## **ADDENDUM 1**

##### **1.1 Drawing M-201 – Mechanical Riser Diagrams and Schedules (Re-issued)**

UTM PROJECT NO. P300-23-095

UNIVERSITY OF TORONTO MISSISSAUGA  
TERRENCE DONNELLY HEALTH SCIENCES COMPLEX  
777 OUTER CIRCLE, MISSISSAUGA ON L5L 1C6

2 DOMESTIC WATER RISER DIAGRAM  
M-201 N.T.S.

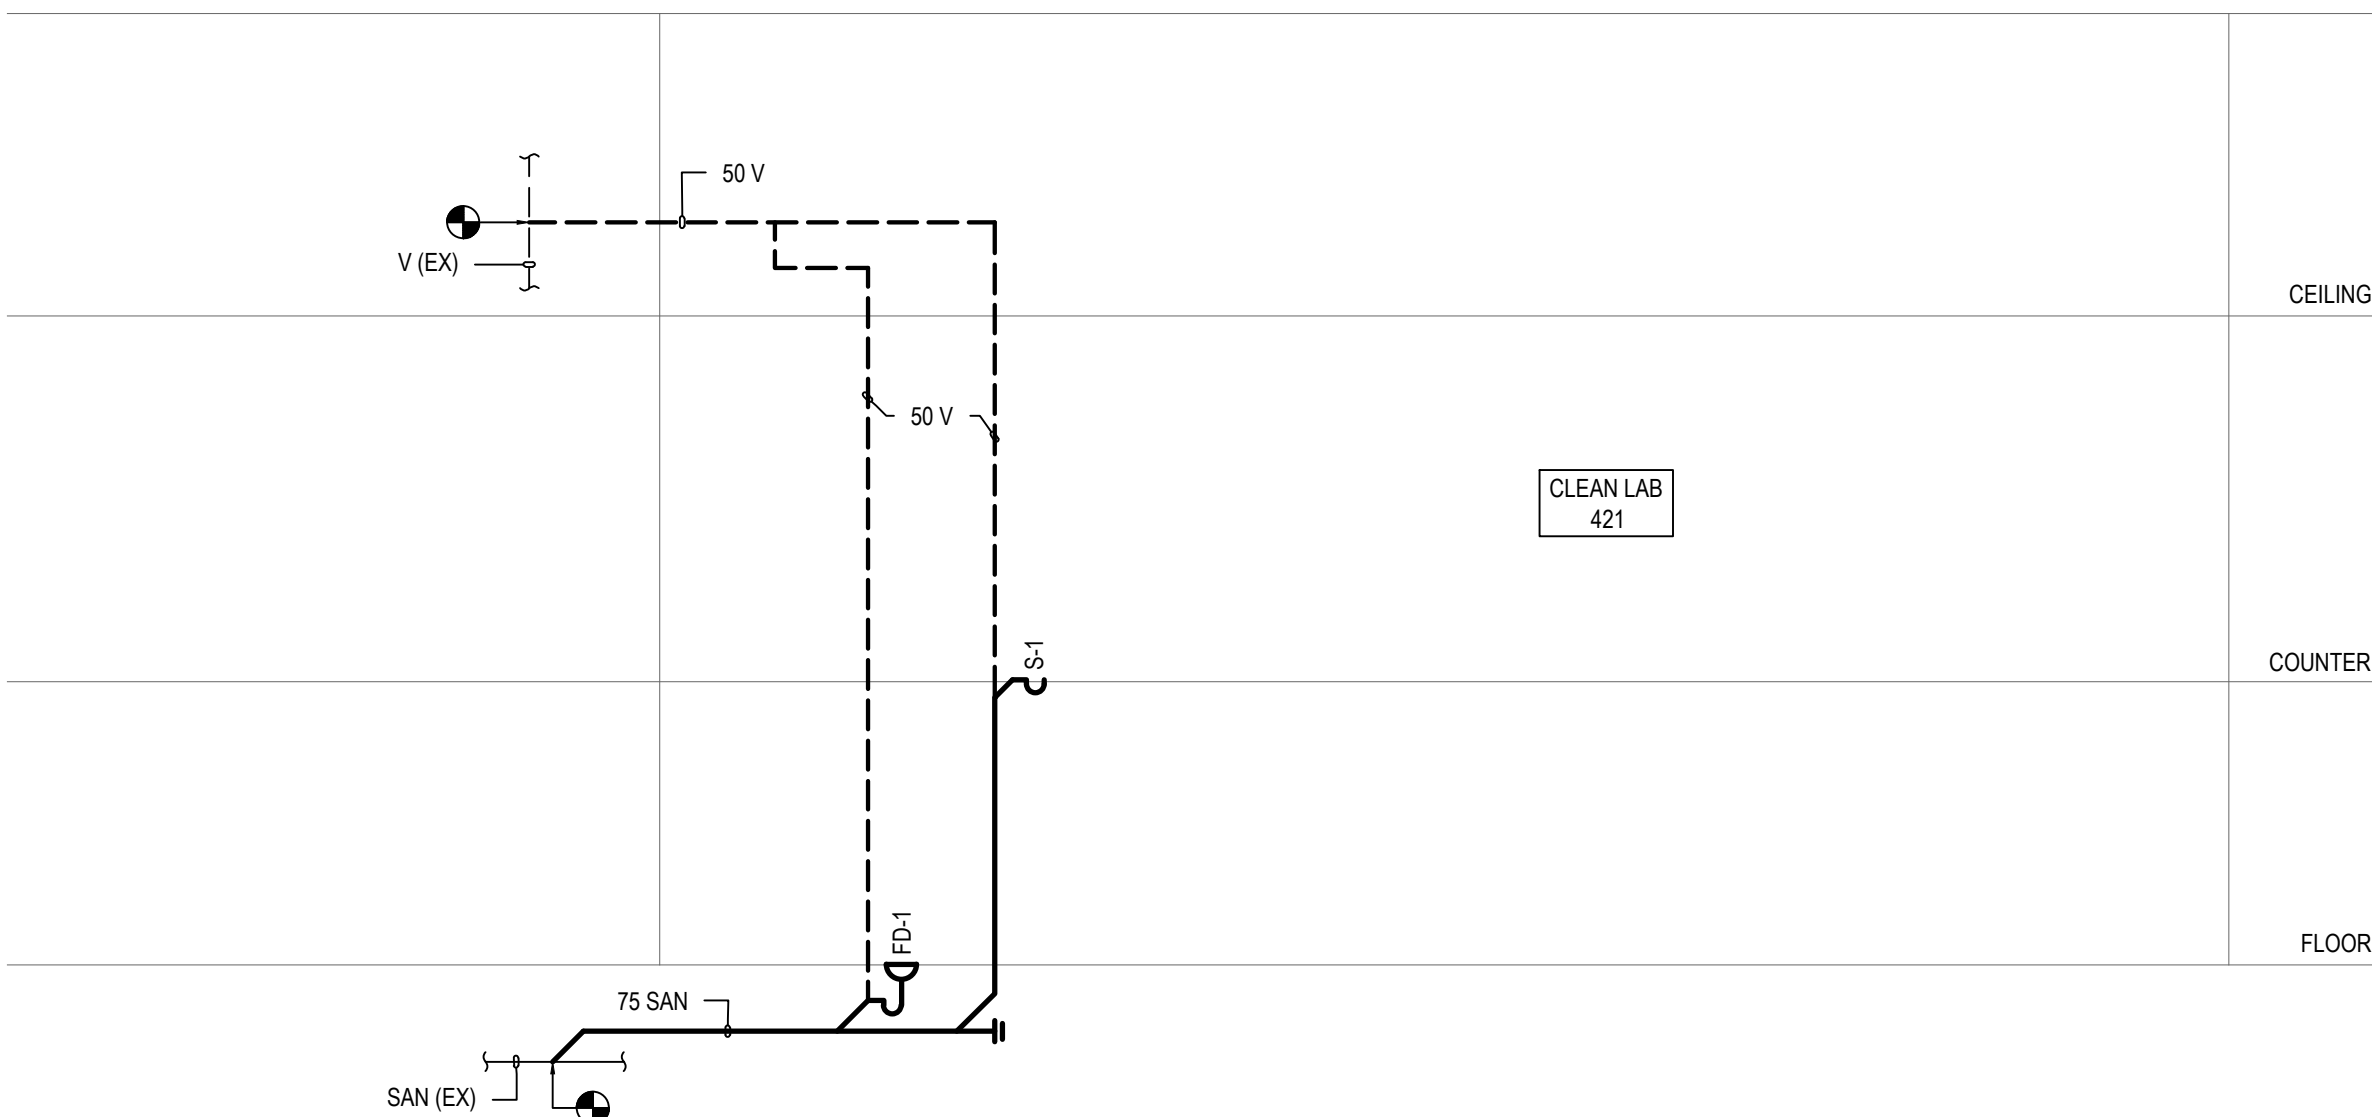
- .1 Revise plumbing fixture connection schedule.
- .2 Revise domestic water riser diagram.
